Subject: Technical Evaluation of Assessments of the Potential for PCE in Groundwater Associated with the MKC site to Impact Unit Well #8

**TECHNICAL EVALUATION OF ASSESSMENT OF THE POTENTIAL FOR PCE IN
GROUNDWATER ASSOCIATED WITH THE MADISON-KIPP CORPORATION
SITE TO IMPACT UNIT WELL #8**

City of Madison Water Utility

Figure 1. Hydraulic head profiles calculated using the MKC site Westbay multilevel system data (Arcadis, 2013). Lithostratigraphic data is approximated from figures provided in Arcadis (2013).

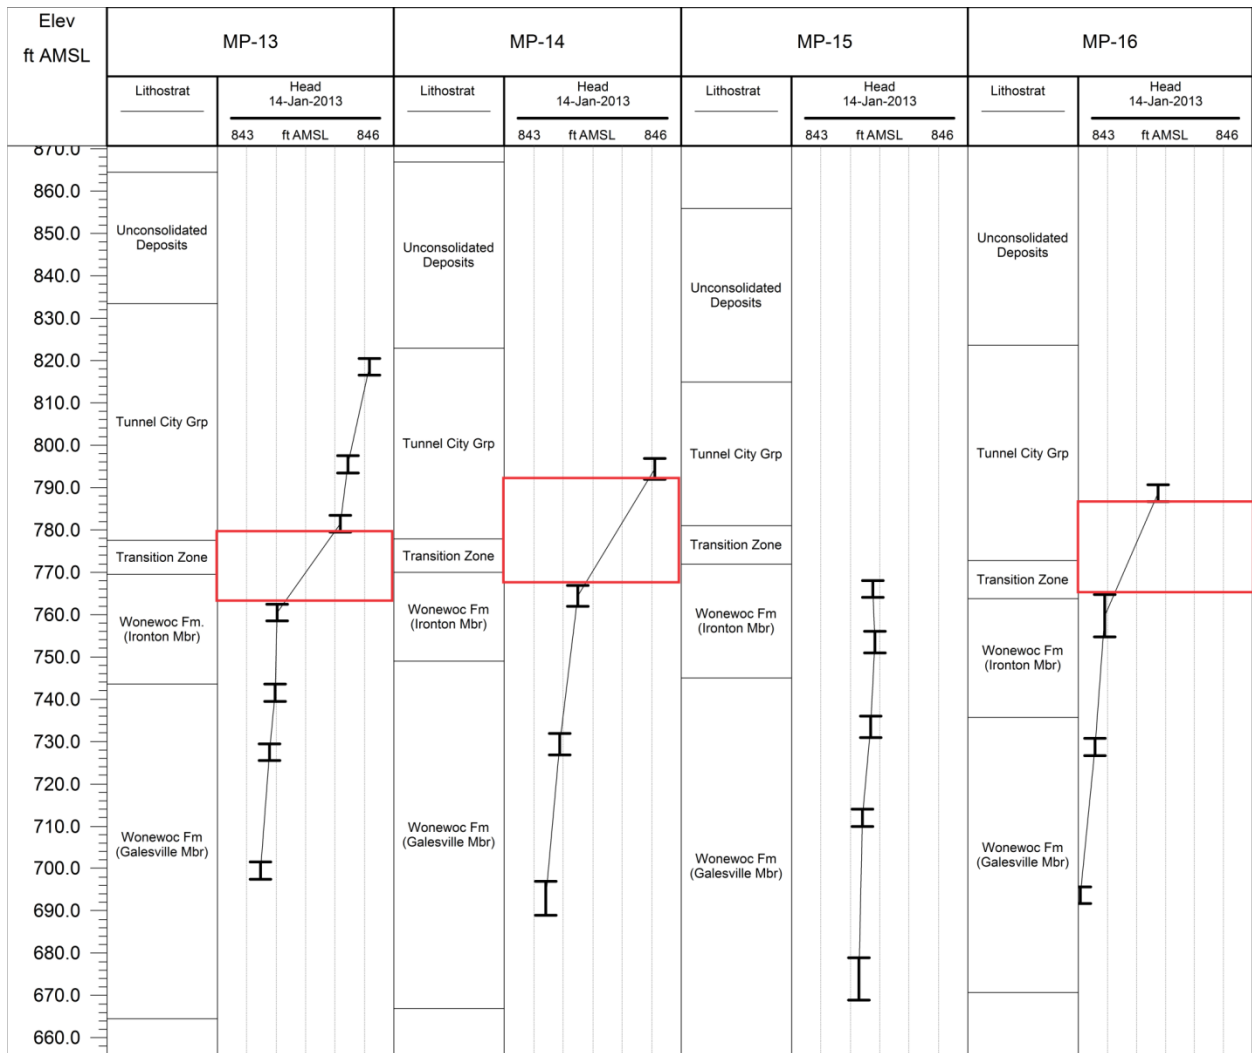
Four Westbay MLS installed at the MKC site provide vertical head profile data; however, hydraulic head profiles are not presented in the site documentation reviewed here. Therefore, head data from the four MLS (Arcadis, 2013, table 4-1) were plotted in order to provide an example of how such data can be utilized and evaluate the existing site hydrogeologic unit conceptual model (Figure 1). The MP-13 head profile shows a sharp decrease in head of 1.07 ft between 780 and 763 ft AMSL. A similar, but less resolved, change in head appears in the MP-14 and MP-16 profiles. This distinct head change roughly coincides with the upper most portion of the Wonewoc Formation which has been described as the Iron-ton transition zone at the site (Arcadis, 2013). The MP-15 MLS does not include monitoring intervals in the Tunnel City Group and therefore does not include the head change. The distinct change in head observed at three locations bracketing the site to the north, west, and east indicates a contrast in hydraulic conductivity that potentially extends across the entire area of the PCE plume. The presence of a laterally extensive hydraulic conductivity contrast within the upper Paleozoic aquifer (Tunnel City Group, Wonewoc Formation, and portion of Eau Claire Formation above the aquitard) would not be consistent with the conceptual model where the upper Paleozoic aquifer functions as a single hydrogeologic unit.

The hydraulic head profiles (Figure 1) also provide additional insight regarding the vertical hydraulic gradients at the site. Arcadis (2013) notes that the vertical gradients are predominantly downward and vary in magnitude between 0.012 and 0.033 for the conventional wells and 0.013 and 0.019 for the Westbay MLS. However, calculation of the vertical gradient associated with the 1.07 ft of head lost across the transition zone in the MP-13 MLS yields a vertical gradient of 0.063. This vertical gradient is calculated by dividing the head loss (1.07 ft) by the distance between the bottom of the upper monitoring interval and the top of the lower monitoring interval (17 ft). The calculation assumes the contrast in hydraulic conductivity responsible for the head loss is 17 ft thick and located between the two monitoring intervals. Research at a nearby field site (Meyer et al., 2008; Meyer et al., 2014) suggest the hydraulic

conductivity contrasts associated with this head loss is substantially thinner than 17 ft and therefore the vertical gradient of 0.063 is likely underestimated.

- Utilizing the site specific data to refine the hydrogeologic unit conceptual model for the site.
- Re-evaluating site specific data within the context of the refined hydrogeologic unit conceptual model
 - Redefine potentiometric surfaces
 - Re-calculate horizontal and vertical components of gradient
 - Reassess range and average values of hydraulic conductivity
 - Provide statistical estimates of other important flow and contaminant transport parameters such as fracture spacing and aperture, matrix porosity, and fraction of organic carbon.
